MAJOR PROJECT ASSESSMENT:
West Wallsend Colliery
Continued Operations Project

Director-General's
Environmental Assessment Report
Section 75I of the
Environmental Planning and Assessment Act 1979

January 2012

Figure 5: Proposed Mine Plan

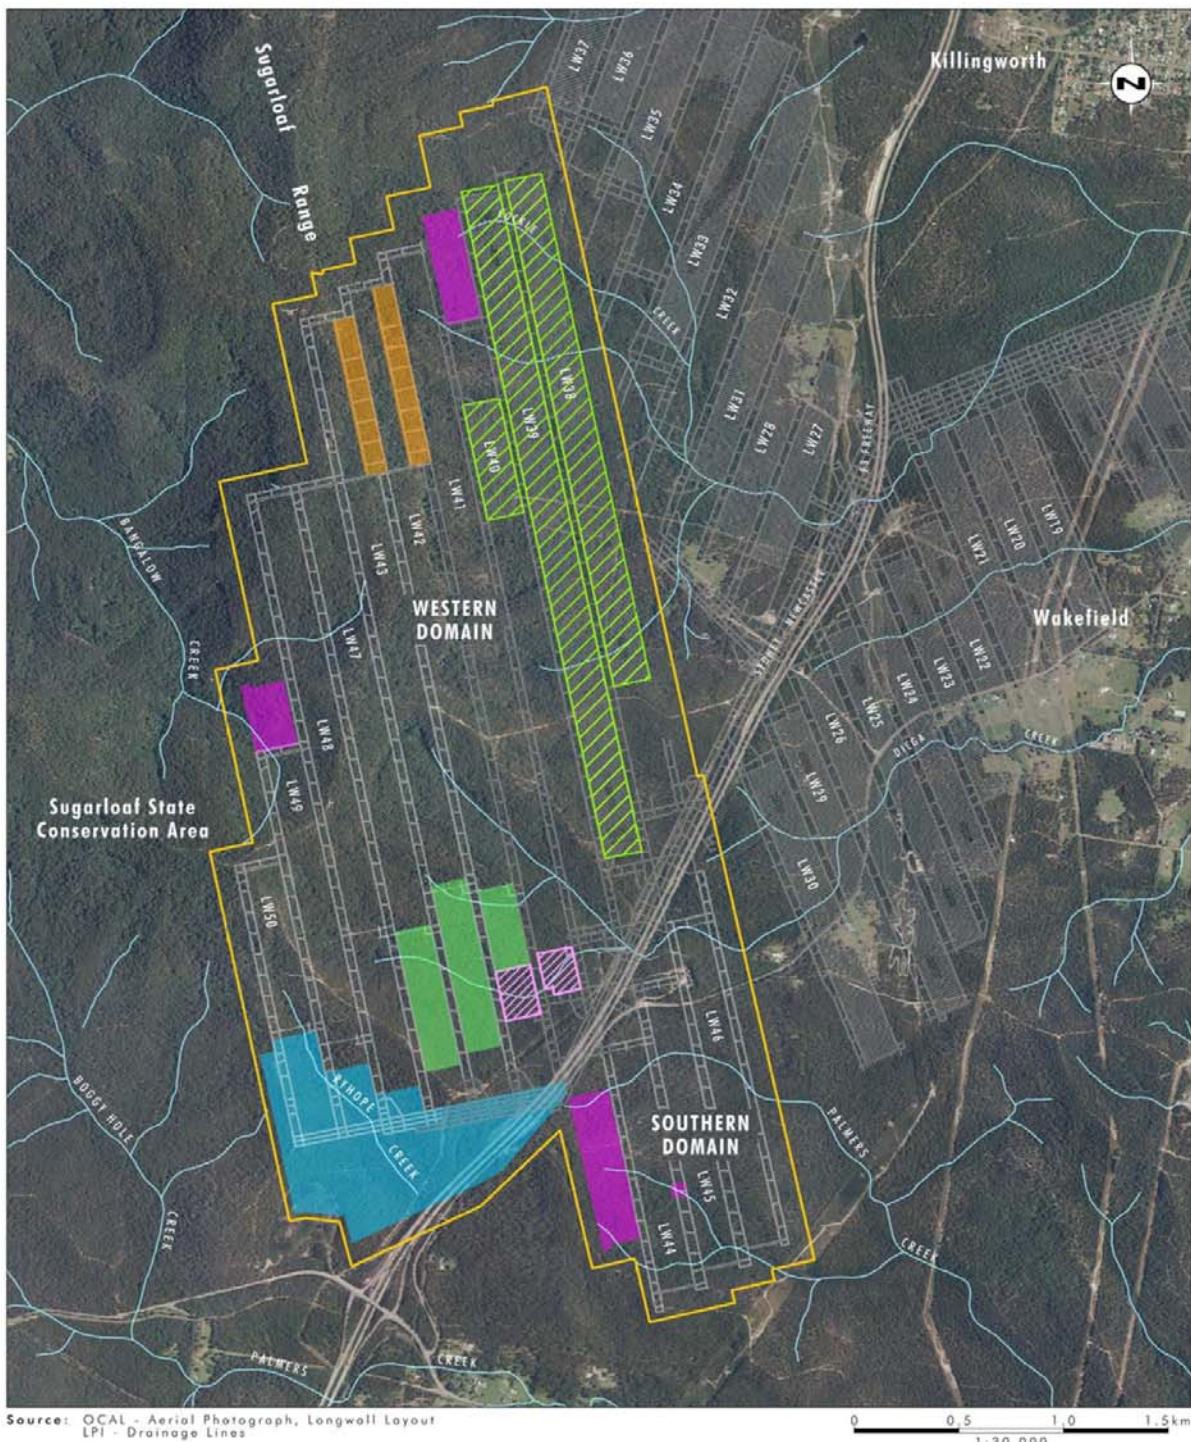
During the course of the assessment, OCAL has made a series of amendments to the mine plan to address issues raised through the consultation process. This report describes and assesses the project as revised. Key changes made to the mine plan to reduce impacts include:

OCAL had previously committed to avoid longwall extraction in areas of the Ryhope Creek catchment where depth of cover was < 70 m (see **Figure 5**). In response to concerns raised by both NOW and OEH in relation to loss of baseflow and associated biodiversity impacts in areas of low depth of cover, OCAL has revised its initial mine plan to avoid areas with less than 80 metres depth of cover (see **Figure 11**). This includes an additional 30 ha area at the southern end of Longwalls 42, 43 and 47 within the Diega Creek catchment (see **Figure 5**).

OCAL's modifications to the mine plan to avoid areas with depth of cover < 80 m would minimise potential indirect impacts from surface cracking and ponding on EECs and GDEs, particularly near Diega Creek (see **Figure 5**). The Department and OEH are satisfied that the revised mine plan greatly reduces the extent and magnitude of predicted subsidence impacts on native vegetation, including EECs and GDEs, and that the overall direct impacts on vegetation are small.

**Figure 7: Location of Cliffs, Cliff Terraces and Steep Slopes**

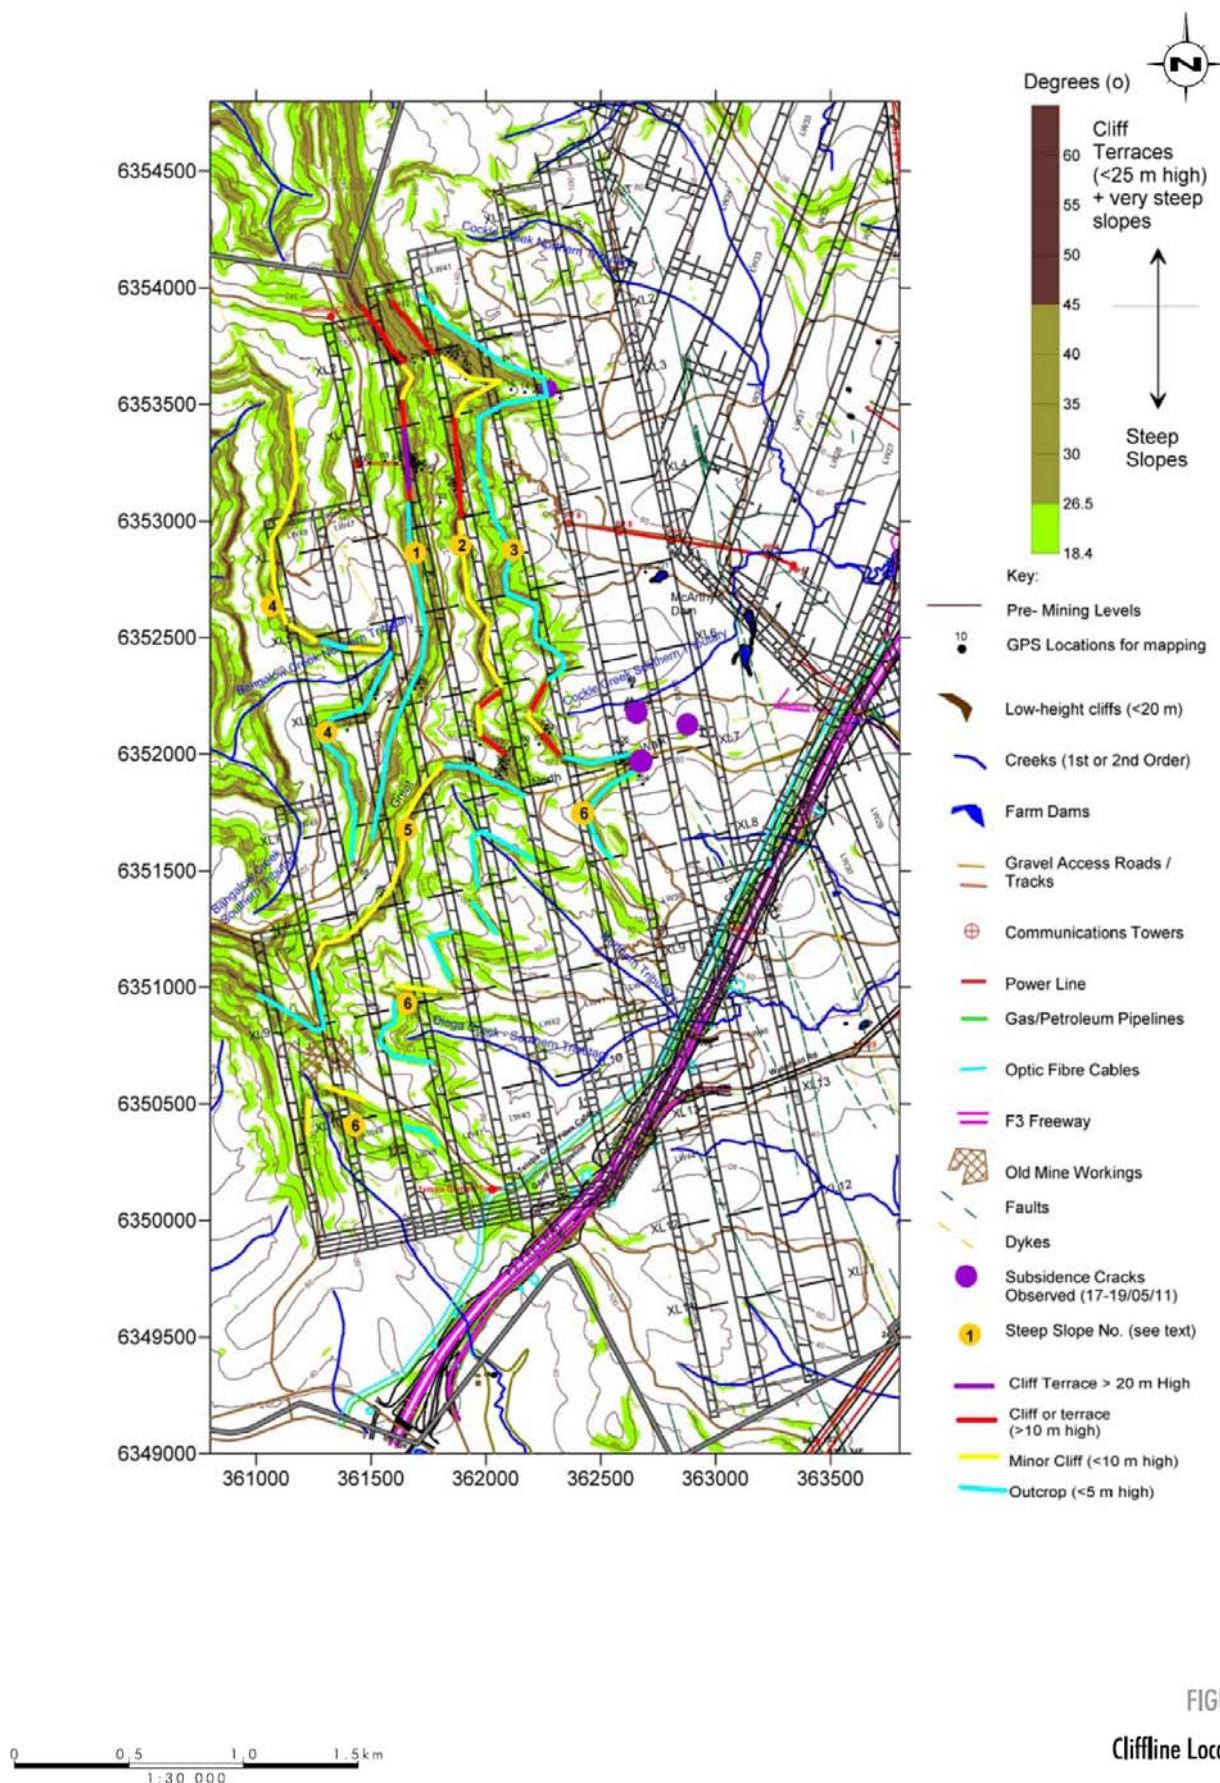
DRE raised concerns in relation to public visibility of rock falls along steep slopes and cliff lines within the project area, particularly in the northern areas of the Western Domain. DRE indicated that these cliffs are regionally significant topographic features as part of the Sugarloaf Range. DGS considers that the only cliff lines that may be publicly visible are located in the northern extent of Longwalls 41, 42 and 43, and the mid-panel area of Longwalls 41 and 42 (see **Figure 7**). Potential views to these cliff lines are generally restricted to commuters along sections of the F3 Freeway. Potential views also exist from residential areas (including West Wallsend and Edgeworth), however these are very long distance views (ie > 10 km) and are well-shielded by topography and vegetation (see **Figure 8**).

However, in order to address the public visibility issue raised by DRE, OCAL has committed to reducing the void widths at the northern extent of Longwalls 42 and 43 from 178 m to 115 m, which DGS predicts would reduce the risk of cliff falls at the potentially visible cliff lines from high to low. This modification sterilises approximately 0.5 Mt of coal, worth between \$37 - 72 million (depending on the fluctuating value of the resource). Although DRE accepted that these modifications would reduce the degree of risk of rockfall on visible cliff faces, it recommended that a number of other mine layout options be considered. These include avoiding secondary extraction under the northern extent of Longwalls 41 to 43 or further minimising panel widths in this area.

The Department is satisfied that the revised mine plan would result in a significant reduction in the risk of mining-induced rock falls along publicly visible cliff lines. However, it does not agree that the public visibility of cliff lines should be the predominant factor in assessing and regulating impacts from rockfalls. Nor does it consider that protection should be offered only for the highest rock faces (ie “cliffs”, or continuous rock faces that are over 10 m in height and >20 m in length). “Minor cliffs” (continuous rock faces with heights between 5 and 10 m and >20 m in length) and “cliff terraces” (combinations of between 2 and 5 minor cliffs in close proximity that result in a stepped profile) are also key landscape features of the mining area and the Sugarloaf SCA more generally. These landscape features have important scenic values for bushwalkers in the Sugarloaf SCA, as well as habitat value and intrinsic value, and are deserving of appropriate standards of protection. However, the Department does not consider that any of the cliffs, minor cliffs or related landscape features at West Wallsend are deserving of being considered as “cliffs of special significance” (as identified by the Planning Assessment Commission in its assessment of major clifflines on river gorges affected by the Bulli Seam Operations Project as being worthy of protection from greater-than-negligible impacts).

The Department’s recommended conditions therefore include subsidence impact performance measures to ensure that the project causes not more than “minor environmental consequences” on all cliffs, minor cliffs, cliff face features, rock face features and steep slopes (as defined) within the proposed mining area. “Minor environmental consequences” are defined as “occasional rockfalls, displacement or dislodgement of boulders or slabs, or fracturing”. The Department proposes that the rigour of this “minor environmental consequences” standard should be applied variously according to the scale, significance and sensitivity of each of these types of features, as follows:

- **Cliffs** – impacts that in total do not exceed 3% of the total face area of these features;
- **Minor cliffs and cliff terraces** - impacts that in total do not exceed 5% of the total face area of these features; and
- **Rock face features and Steep slopes** - impacts that in total do not exceed 7% of the total face area of these features.

Figure 9: Existing Utility Locations and Surface Features within the Mining Area

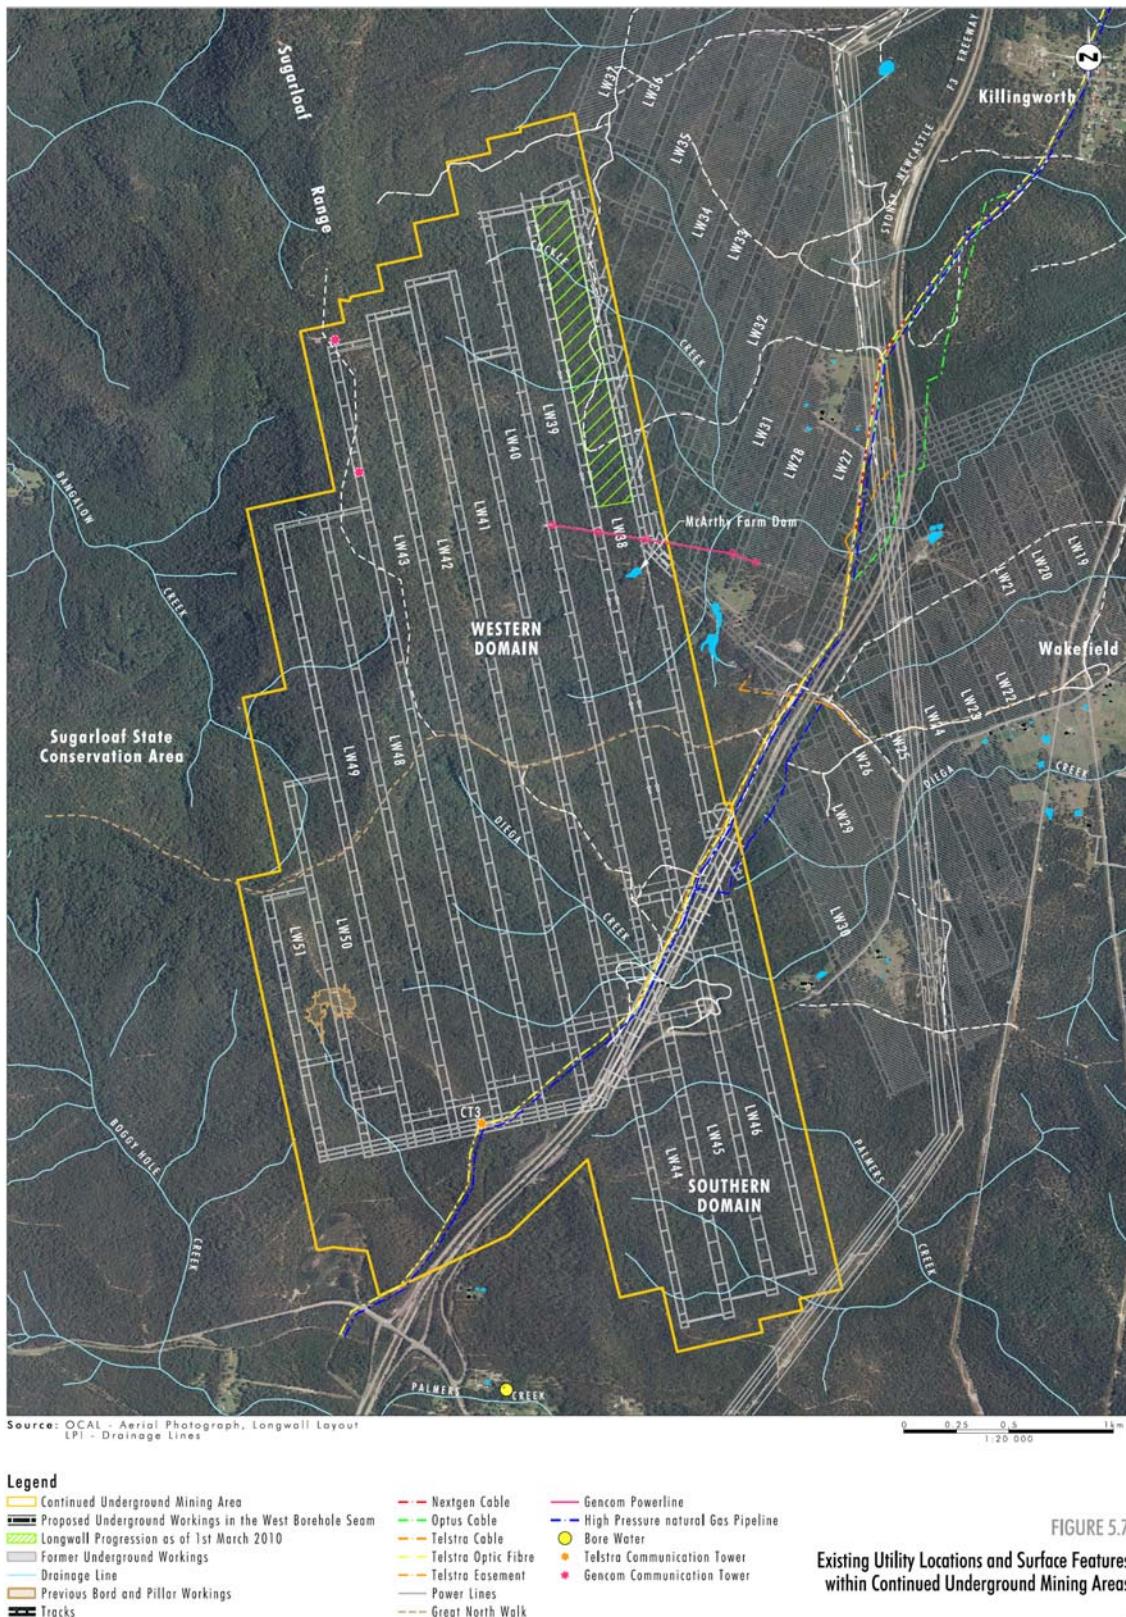
The EA indicates that the overall mine layout has been designed to minimise subsidence impacts on this infrastructure and utilities. This especially includes the F3 Freeway and associated services easement, where a significant barrier of coal would be retained between the Western and Southern Domains to ensure the Freeway is outside the angle of draw. In addition, to manage the potential for far-field impacts beyond the angle of draw, OCAL has developed a management plan in consultation with the RMS. This should ensure that the Department's proposed performance measure, that this key

public infrastructure always be kept both “safe and serviceable”, is maintained. As requested by the RMS, in order to ensure that the existing management practices continue to be implemented, the Department has recommended a condition requiring the management plan to be updated as part of the project’s Extraction Plan.

The Department has recommended performance measures requiring OCAL to ensure public infrastructure and utilities are maintained in a safe and serviceable condition and, if required, any damage is fully repaired or else replaced or fully compensated. In addition, the Department has recommended that OCAL be required to prepare and implement a Built Features Management Plan as part of the Extraction Plan.

Figure 12: Potential Areas of Creek Bed Instability

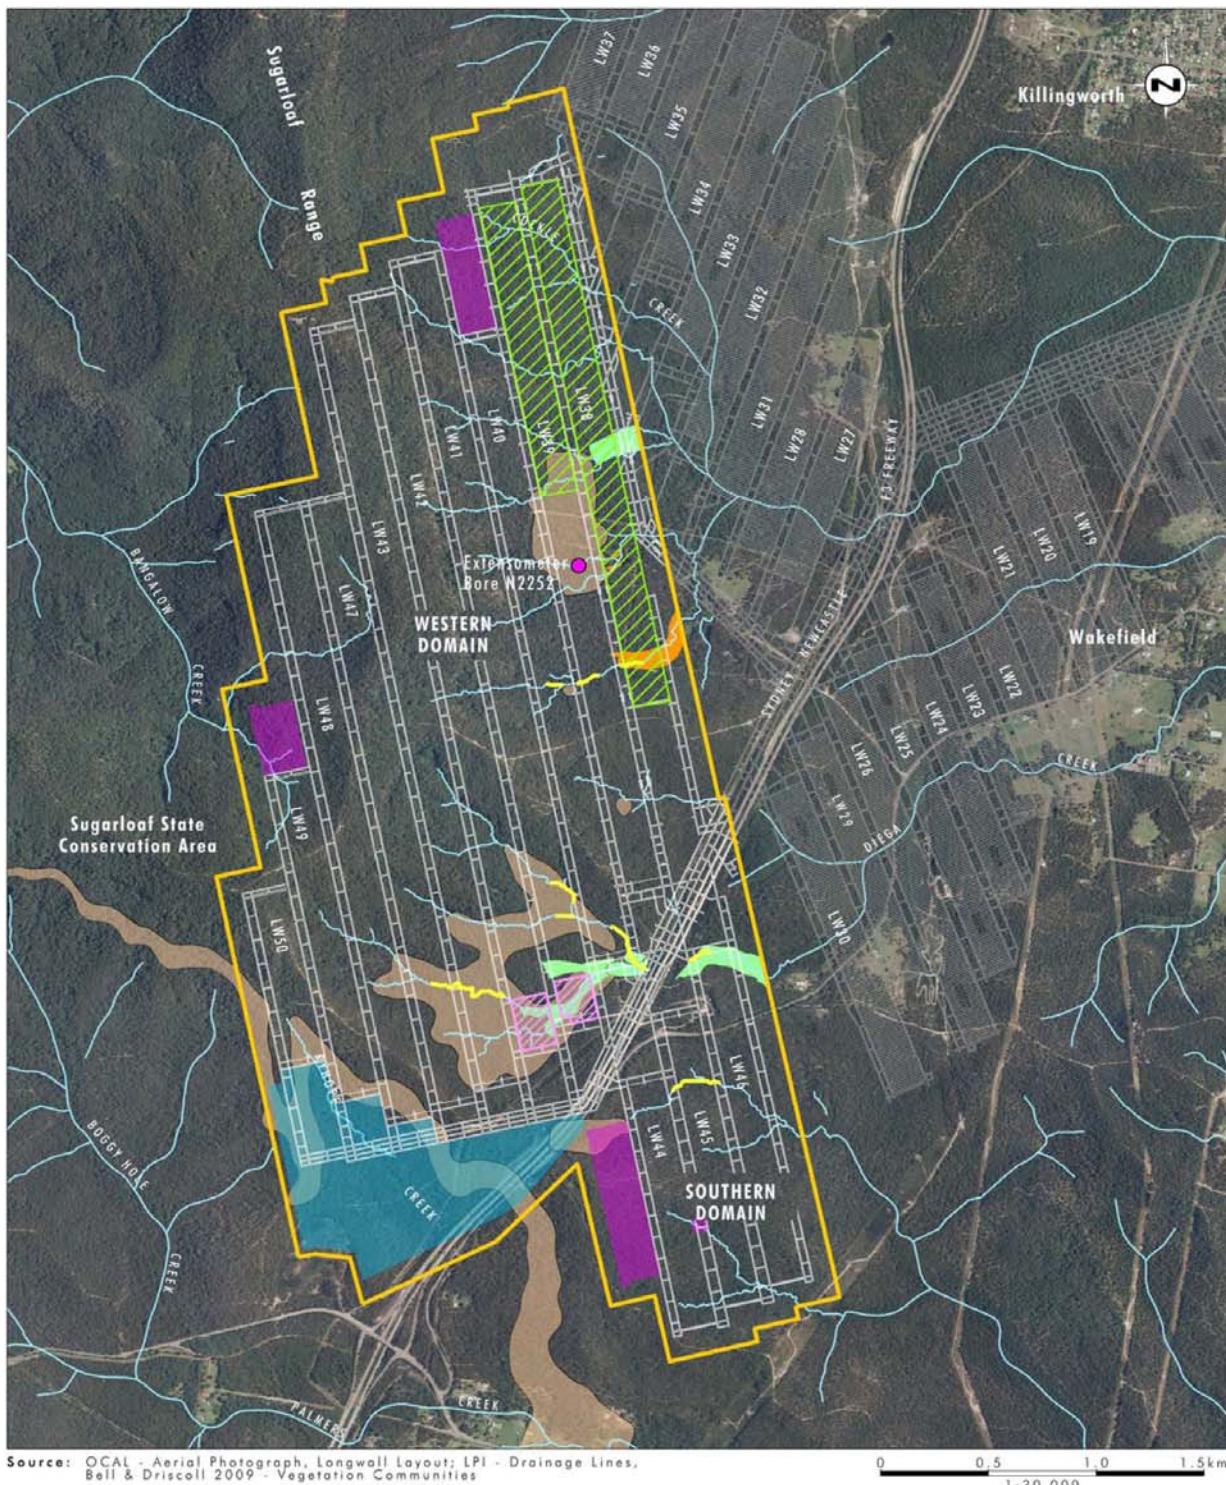
Mine subsidence also has the potential to alter parts of the longitudinal grade of watercourses, resulting in potential increases in flow velocities and greater potential for erosion and sediment laden water to enter downstream waterways. In response to requests by OEH, the CMA and NOW, OCAL undertook additional modelling in order to determine potential changes in peak velocities that may occur as a result of subsidence. The modelling indicated that particular sections of some creek lines are at risk of becoming unstable as a consequence of mining (see **Figure 12**). The Department notes that the longest affected reach (in Diega Creek) would now be avoided under the modified mine plan.

For other areas, OCAL has committed to conducting frequent inspections of the creeks both prior to and post mining to ensure that they remain stable, with no additional erosion of the creek bed or banks. If instability is identified, OCAL has committed to implementing a stability program, which would involve placement of controls such as coir logs, tree logs, or hard rip rap within creek beds and along creek banks to reduce flows and stabilise the system, where necessary.

OEH and NOW accepted this approach, however NOW requested that OCAL undertake more detailed investigations along creek lines to be undermined to more accurately define their geomorphic character, nature of the bed load material, predicted stream velocities, and nature and location of any controls required to minimise degradation of stream channels. The Department has recommended a condition requiring OCAL to detail this information in the Water Management Plan component of the Extraction Plan.

The Department is satisfied that these measures would result in continued creek stability in the mining area.
